kSIST FprHD 60364-7-701:2019/oprAA:2023

Nizkonapetostne električne inštalacije - 7-701. del: Zahteve za posebne inštalacije ali lokacije - Prostor s kopalno kadjo ali tušem - Dopolnilo AA

DRAFT
FprHD 60364-7-701:2019
prAA

Low-voltage electrical installations - Part 7-701: Requirements for special installations or locations - Locations containing a bath or shower

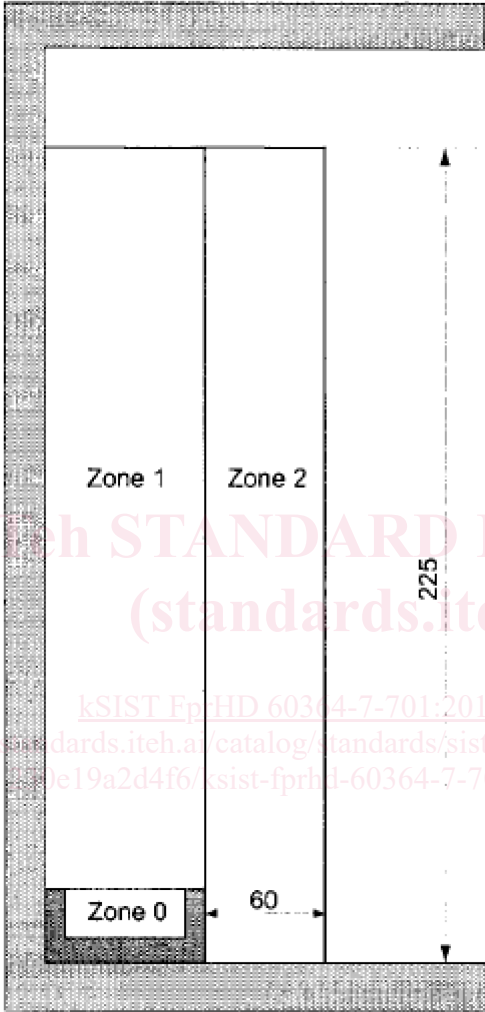
<u>(Sub)clause</u>	<u>Special national condition</u>
<p>Figure 11</p>	<p>Add new Figure 11 as Special National Condition (SNC) for Germany: Figure 11 Dimensions of zones in locations containing shower with a basin</p>  <p>The diagram shows a cross-section of a shower area. Zone 0 is a shaded rectangular basin at the bottom left. Zone 1 is a vertical rectangular area above the basin. Zone 2 is the remaining space in the room. A horizontal dimension line indicates a width of 60 for Zone 0. A vertical dimension line indicates a height of 225 for Zone 1. A watermark 'STANDARD PREVIEW (standards.iteh.ai)' is overlaid on the diagram.</p> <p>Figure 11 — Dimensions of zones in locations containing shower with a basin</p>
	<p>United Kingdom</p>
<p>701.1</p>	<p>Add the following note: NOTE 5 the term “locations” may be interpreted as rooms of buildings</p>
<p>701.30.102</p>	<p>Add the following note: NOTE for showers without basin, the height of zone 0 is 5 cm.</p>
